Service Bulletin

Bulletin No.: 20-NA-198

Subject: Trailer Running Lights Shut Off Due to Excessive Load on the Running Lamp Circuit

Brand:	Model:	Model Year:		VIN:		Engine:	Transmission:
		from	to	from	to		
Chevrolet	Silverado 1500 (New Model)	2019	2019			All	All
GMC	Sierra 1500 (New Model)

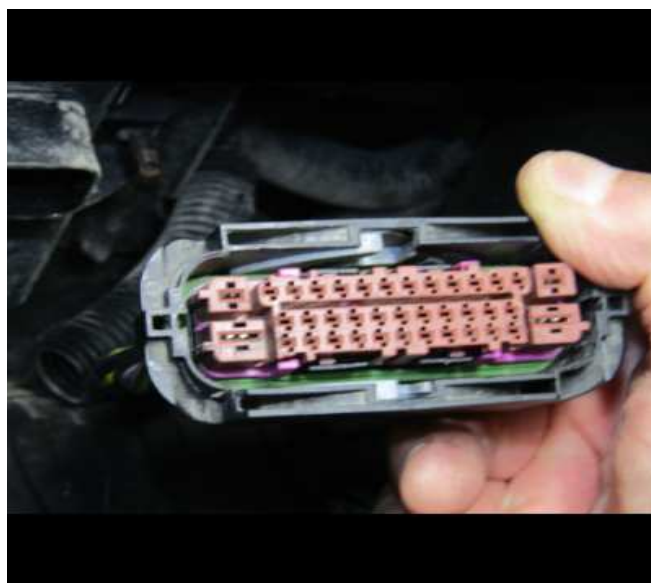
6. Locate the Gray/Brown wire, at pointer (1), connected to cavity 5, and cut the wire approximately 7.62 cm (3.0 in) from the connector body. The wire will be re-located to cavity 25 (2).

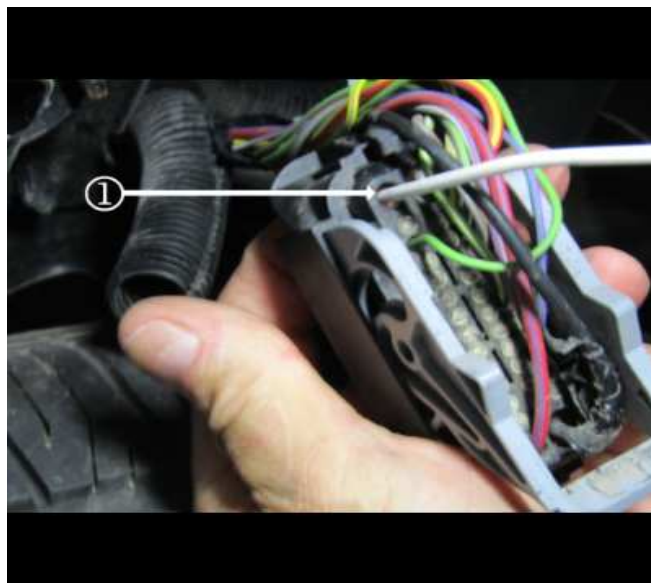
7. Release the 4 tabs on the connector body and pull slightly upward to partially release it from the connector housing.

8. Push the terminated lead (1) from the new white wire splice into cavity 25.

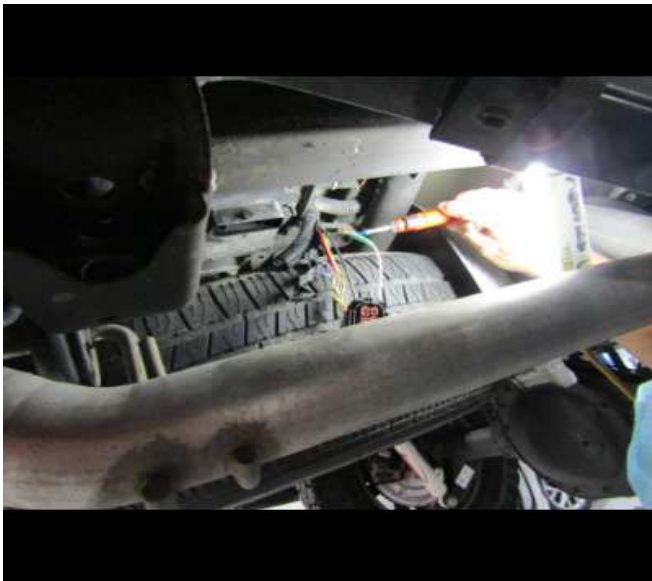
9. Cap the previously cut Gray/Brown wire and seal with a closed end duraseal splice. Take the open end of the white wire, add a duraseal and connect to open cut end of the Gray/Brown wire.
